**Re: Intersection of Ainsworth Close and Jameson Avenue, East Ballina  
Doc No. 20/40027, 20/67015**

10.1 Ainsworth Close/Jameson Avenue Intersection - Road Safety

SURVEY BSC		DESIGNED		BALLINA SHIRE COUNCIL		
					DATE 23/6/2021		DRAWN MNF				
					F.B. L.B.		CHECKED DK		PROPOSED NO STOPPING LINEMARKING AINSWORTH CLOSE JAMESON AVE EAST BALLINA		
					DATUM		APPROVED				
					DRAWING - AINSWORTH CLOSE.DWG						
No.	Date	By	Change	X'd	Scale 1:200			Plan No.		A4	
Amendments

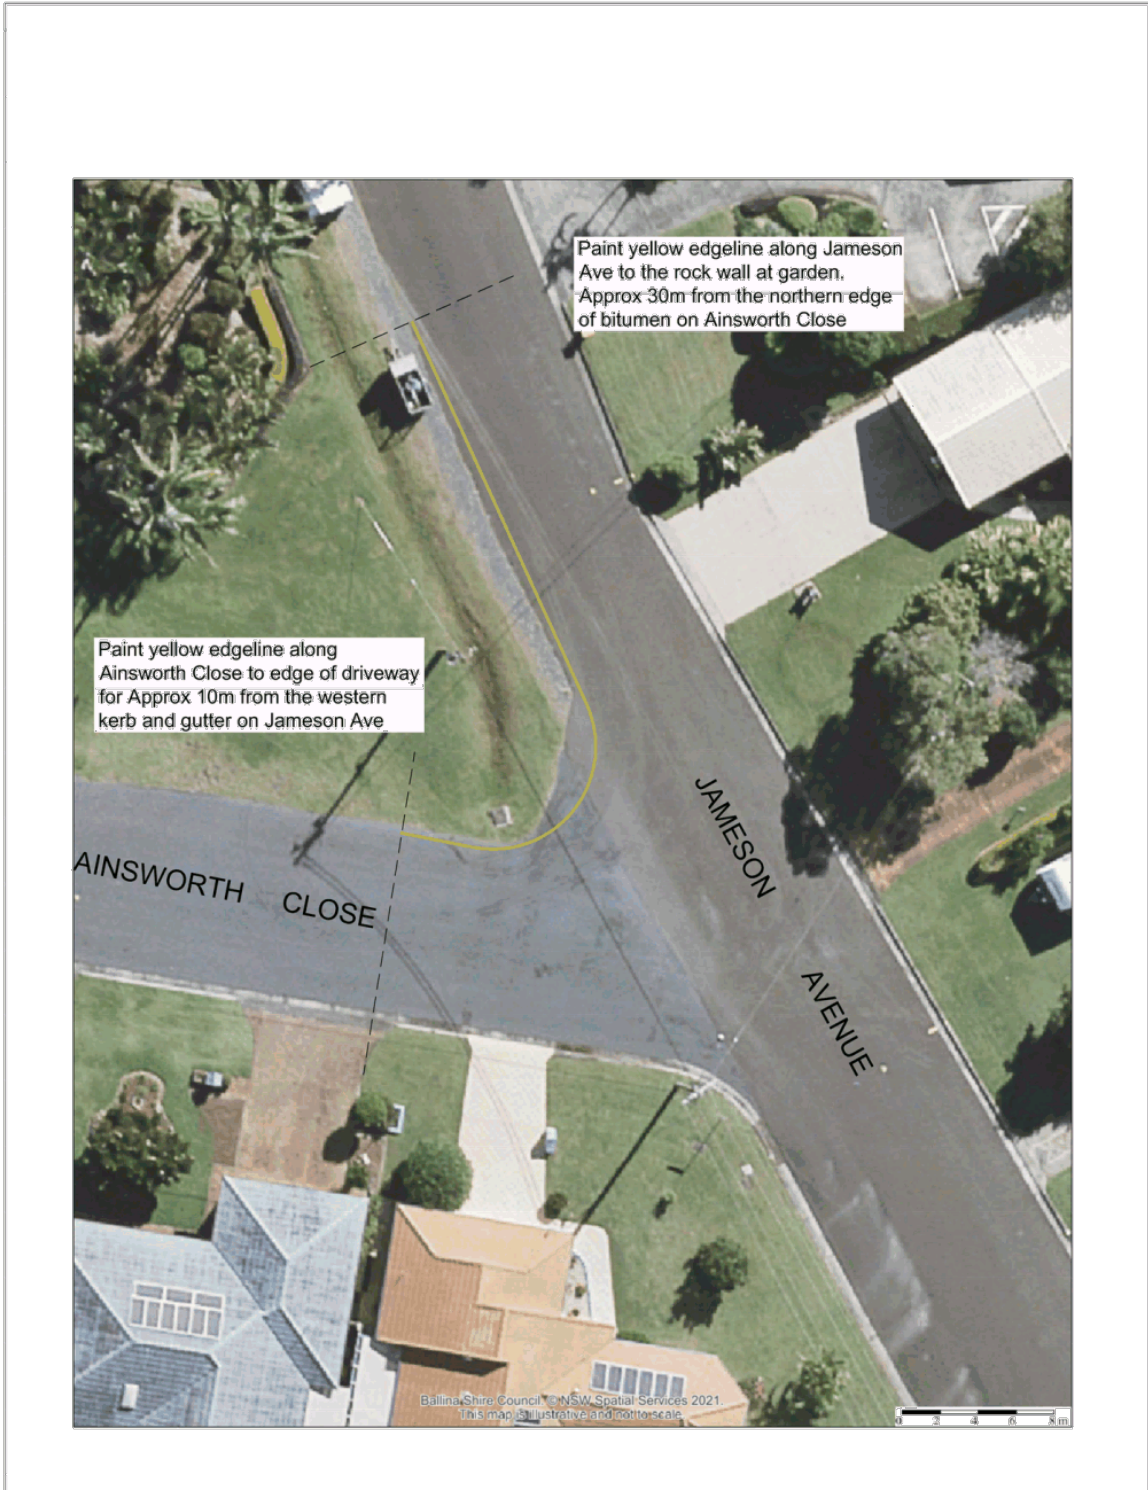
As you are aware, the intersection is approximately 40 years old and the approval considered the standard that applied at the time. Sec D1.17 of the Northern Rivers Development Design Manual says intersection should be 90 Degrees and not less than 70 Degrees (the subject intersection is approximately 45 Degrees).

Section 3.1 of the Austroads Guide states that large angles can be a significant issue with older drivers especially those who have difficulty with their head and neck to detect the presence of conflicting vehicles. Many of the residents in Ainsworth Close are aged and all are having extreme difficulty with the intersection with all residents have numerous "near misses".

There is a large amount of residential units located on the North Eastern side of Jameson Avenue with many owning or driving trade or delivery trucks which add to the problem of ingress from Ainsworth Close to Jameson Avenue.

Mr Chris Pickford of Newton Denny Chapelle has inspected the site and has concluded that the realignment should not be overly expensive.
